2-NSW-138 (Sheet 1 of 2)
Upper Containment Ventilation
Unit 1 Return Line

LIVSEY & COMPANY, INC.
INDIANA & MICHIGAN ELECTRIC CO.
DONALD C. COOK NUCLEAR PLANT

CONTAINMENT BLDG.
DWG. NO. 2-NSW-138
SH. 1 OF 2
REV. 1

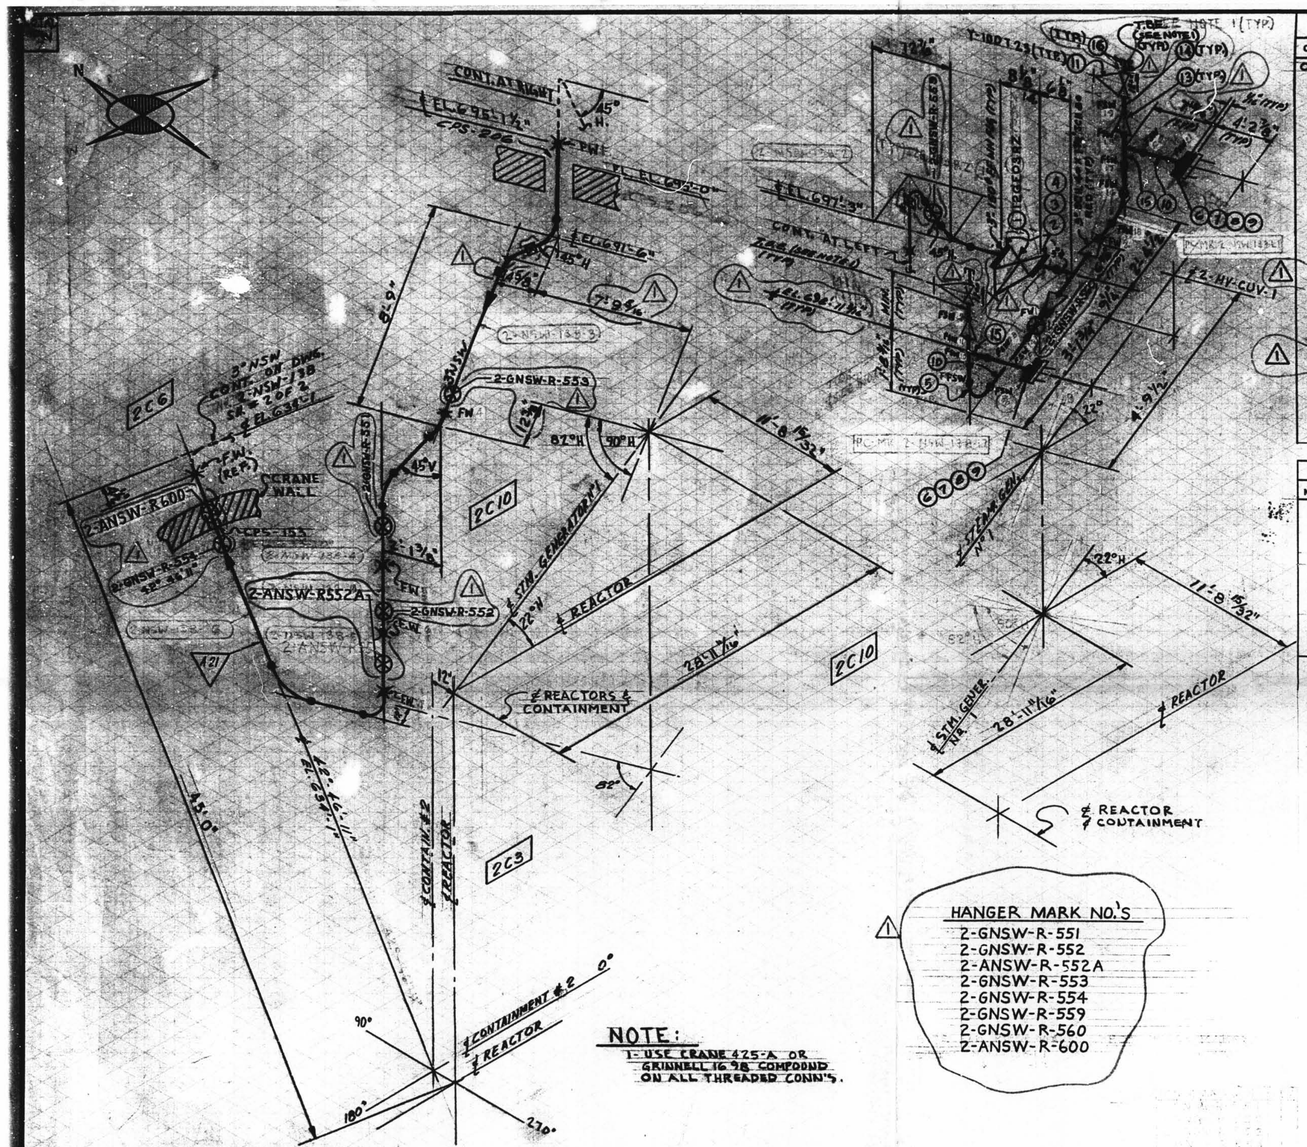
| NO. | DATE | DRAWN/CHK'D | DESCRIPTION | REMARKS |
|---|---|---|---|---|
| | | BWD | TO REFLECT AS BUILT COND. FOR REF. DC-12-3070: ADDED SUPPORT MARK NOS & SUPERSEDED HGR. ISO 2-GNSW-138 (SHT. 1); REVISED H.W. ORIENTATION OF ITEM 13, FLOW DIAGRAM REF. NO. SHEET 5 & B/M TO SUIT. | NO FIELD ACTION REQ'D |
| 1 | 12/29/89 | BC LB GJB DDM LB | PER REF. DC-02-2908 THIS DRAWING ISSUE IS FOR AS-BUILT INFORMATION ONLY ADDED NEW FIELD WELDS. PER INFORMATION ON DWG. M-5GR-2-NSW-138-1 REV. 4, DCDR-047, DCDR-243 & FIELD SKETCH FIG. NO. 5. | |
